COMMUNITY DESIGN REVIEW BOARD STAFF REPORT

REPORT TO: Melinda Coleman, City Manager
REPORT FROM: Michael Martin, AICP, Assistant Community Development Director
PRESENTER: Michael Martin, AICP, Assistant Community Development Director
AGENDA ITEM: New Maplewood Elementary School, 2410 Holloway Avenue East
a. Conditional Use Permit Resolution
b. Design Review Resolution

Engineering Plan Review**PROJECT: New Elementary School – 2410 Holloway Avenue****PROJECT NO: 20-12****COMMENTS BY: Jon Jarosch, Assistant City Engineer****DATE: 5-8-2020****PLAN SET: Engineering plans dated 4-20-2020**

Environmental Review

**LANDSCAPE
PLAN - NORTH**

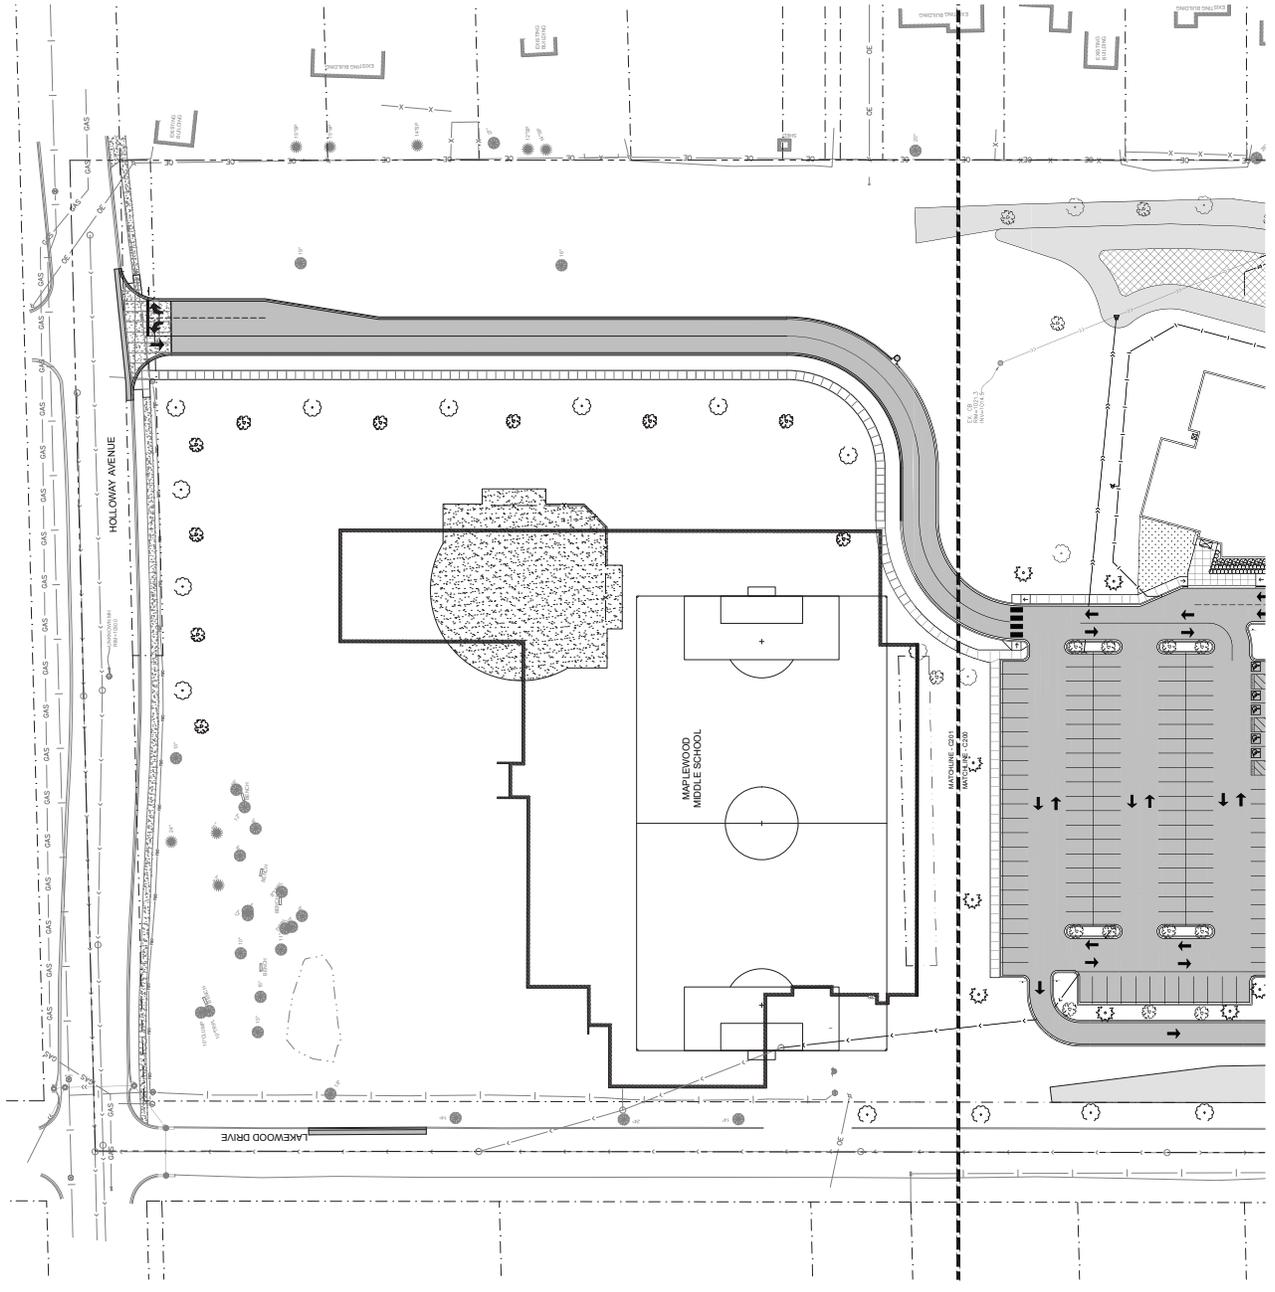
A minimal landscape plan was submitted identifying the location of trees. However, there is no legend on the landscape plan that outlines the tree species, size, and number of trees to be planted.

- 1) The planting schedule has very low diversity. Consider increasing tree and shrub diversity to add visual interest and limit the number of affected plants in case of disease.
- 2) Chicagoland Green Boxwood: This shrub's Hardiness Zone is 5-8. Maplewood is Zone 4 so this plant will likely not survive the winter. Please choose a different species.
- 3) Pine Tree: Please specify species.

- 6) Plant Schedule: The City would like Eulalia Grass (*Miscanthus sinensis* 'Morning Light') to be removed from the plant schedule. *Miscanthus* has the potential to escape to nearby natural areas and become invasive, especially if it hybridizes with a nearby plant of a different cultivar. It is recommended that Eulalia Grass be replaced with a different grass such as Feather Reed Grass or Switchgrass.

- 1) Submit a tree plan that meets the City's tree preservation ordinance.
- 2) Submit a landscape plan that identifies the number, size, and species of trees proposed to be planted on site.

- 2) The City would like to see a minimum of 5,000 square feet of planted areas for each of the two infiltration basins.
- 3) Provide a landscape drawing for each infiltration basin, including list of species, container size, spacing, and quantities.
